Package Title : Construction of Tunneling Works including Testing and Commissioning for Double Line High Speed Railway using Tunnel Boring Machine (TBM) and New Austrian Tunneling Method (NATM) between Mumbai Underground Station at Bandra-Kurla Complex (MAHSR Km. 0.773) and Shilphata (MAHSR Km. 21.150) in the State of Maharashtra for the Project for Construction of Mumbai-Ahmedabad High Speed Rail.

Package No : MAHSR-C-2

**Response to Bid Queries – 4**

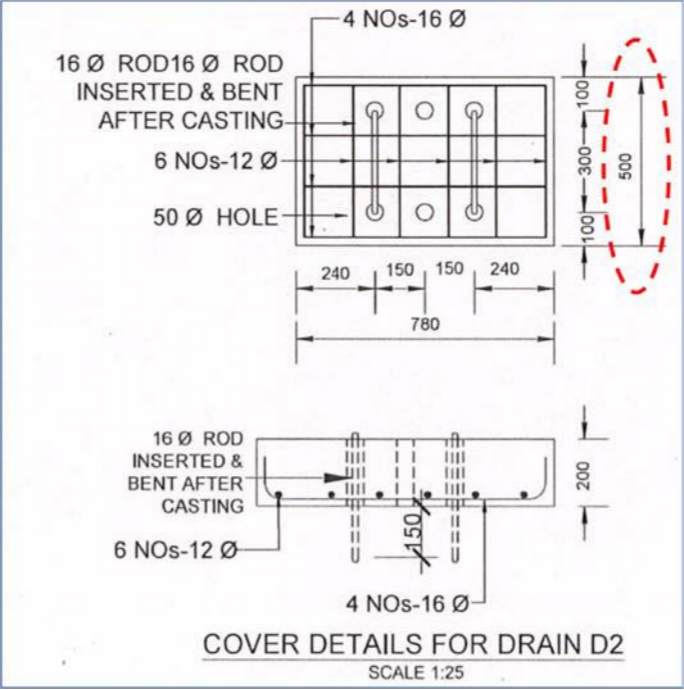
<p>The above modifications are very much essential for the Contractor to maintain a workable and healthy cash flow at site to carry out construction activities without any financial constraints.</p>	Completion of TBM Design and Commencement of TBM Manufacturing	Nos.	3	Factory Acceptance Test	Nos.	3	Receipt of TBM's at site	Nos.	3	Successful Commissioning	Nos.	3	
Completion of TBM Design and Commencement of TBM Manufacturing	Nos.	3															
Factory Acceptance Test	Nos.	3															
Receipt of TBM's at site	Nos.	3															
Successful Commissioning	Nos.	3															
22	Part 1, Section II, BDS	ITB 7.1	"The Employer's response will be uploaded on the Employer's webpage no later than twenty-eight (28) days prior to the deadline for submission of Bids, provided that such request is received no later than forty-nine (49) days prior to the deadline"	Bidder would like to apprise that Addendum No. 4 has been released by the Employer on 8th Aug'19. New/Revised Drawings, Revised BOQ's and other details as released needs detailed review and there might be few points which needs further clarification from the Employer. Accordingly, it is requested to modify the provision as "..... such request is received no later than Twenty Eight (28) days prior to the deadline"	Refer Addendum No. 5 Item No. 3.												
23	Part 1, Section II, BDS	ITB 22.1 & 25.1, Page 9 of 31	The deadline for Bid submission is: Date: 24th September 2019 Time: 15:00 hrs	Bidder would like to inform that there are many techno- commercial issues that are yet to be clarified. Further, more than 1000 drawings have been issued by the Employer, which needs thorough study and detailing. Therefore, the bid extension of only 1 month, as granted is not enough to prepare a comprehensive techno- commercial bid for a project of such magnitude and complexity. Accordingly, it is requested to extend the bid submission by a further period of 1 month; i.e. up to 24 <sup>th</sup> October 2019.	Refer Addendum No. 5 Item No. 2.												
24	Drawing TD-JIC-IC1- B01-UST-NTU- 10330000 & TD-JIC- IC1-B01-UST-NTU-10330001		Steel Segment for Opening of Equipment	From the drawing, Bidder understands that only removal of indicated steel segment will not create access to the Equipment room opening, as indicated by Cross (X) in the figure. This will need further Metal arc Cutting at site location, as well. <ol style="list-style-type: none"><li>1. It is requested to confirm our understanding, as we fear it may damage the Coatings.</li><li>2. Also, please confirm that Clause 4.8.5 (Infill Concrete of Steel segments) is not valid for TBM Segments and is valid only for segments of Equipment Room.</li></ol>	<ol style="list-style-type: none"><li>1. Cutting of steel segments of Main Tunnel will be required at site as shown in the Drawings.</li><li>2. Infill concrete of steel segments shall be provided for segments</li></ol>

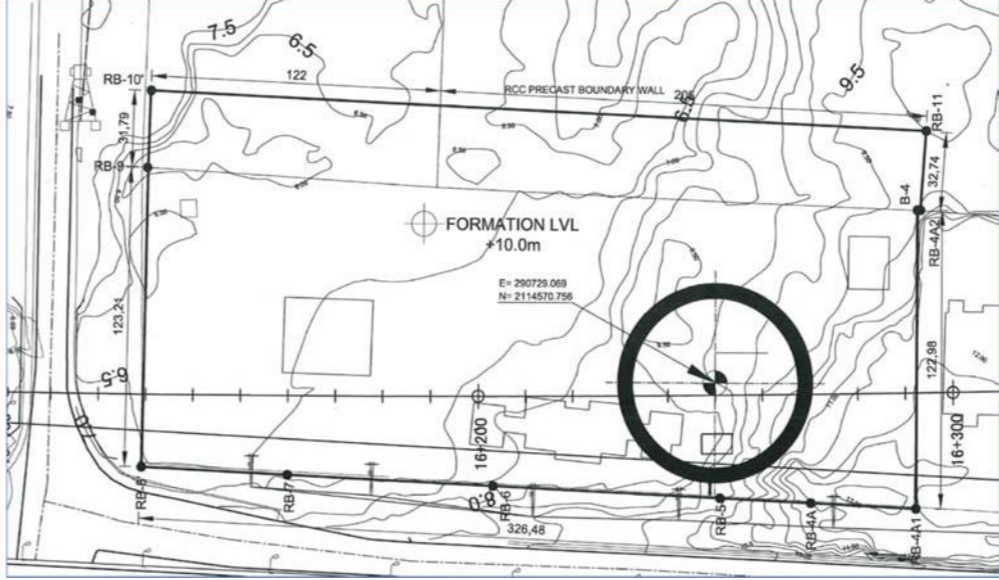
Sl. No	Document	Page no / Clause No.	Provisions as Per-Bidding Documents/Subject/Title/Item as mentioned by the Bidder	Bidder Query	Employer's Reply
				 <p>Please provide the correct information.</p>	
39	Part 2 Section V1-3 Drawings from Addendum No. 2 <b>G. COMMON DRAWINGS</b> <b>TD-JIC-IC1-TDC-B07-UST-NTU-00470000 (NEW)</b>	Page 11 of 19	Discrepancy on the drawing.	1. <u>Drawing 00470000 / PERMANENT REINSTATEMENT AND ASSOCIATED WORKS (DETAIL OF CATCH PIT – TYPE B)</u> There are discrepancies between Section-AA and BB.	Refer Addendum No. 6 Item No. 1.
